KEWAUNEE POWER STATION IMPROVED TECHNICAL SPECIFICATIONS CONVERSION

ITS CHAPTER 4.0 DESIGN FEATURES

Revision 0

**Current Technical Specification (CTS) Markup
and Discussion of Changes (DOCs)**

FIGURE TS 5.4-1
MINIMUM REQUIRED FUEL ASSEMBLY BURNUP AS A FUNCTION OF
NOMINAL INITIAL ENRICHMENT TO PERMIT STORAGE IN THE TRANSFER CANAL

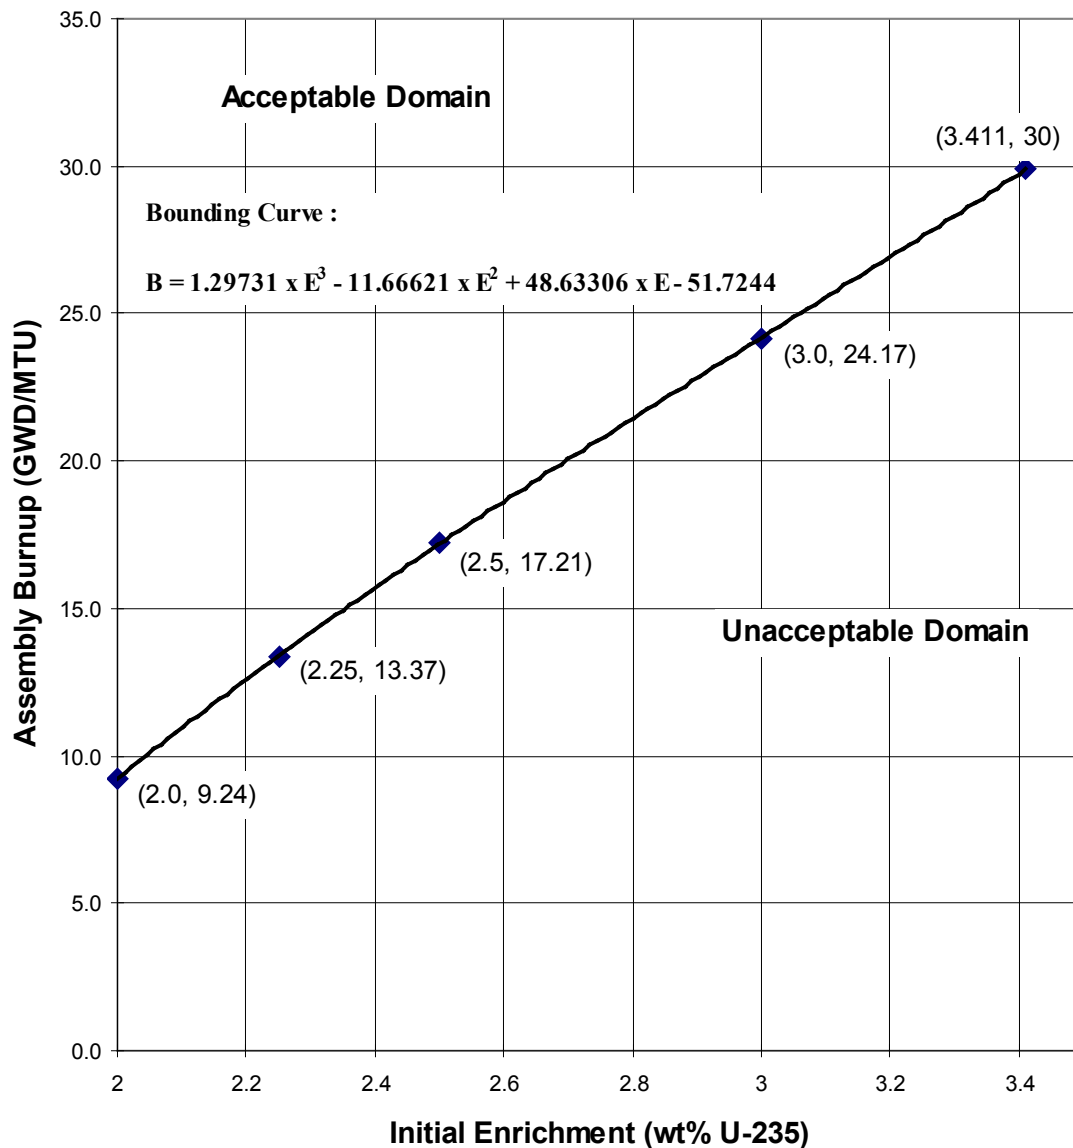
Fuel assemblies stored in the canal racks shall meet the minimum required fuel assembly burnup as a function of nominal initial enrichment as shown in Figure TS 5.4-1. These assemblies shall also have been discharged prior to or during the 1984 REFUELING outage.

See ITS 3.7.15
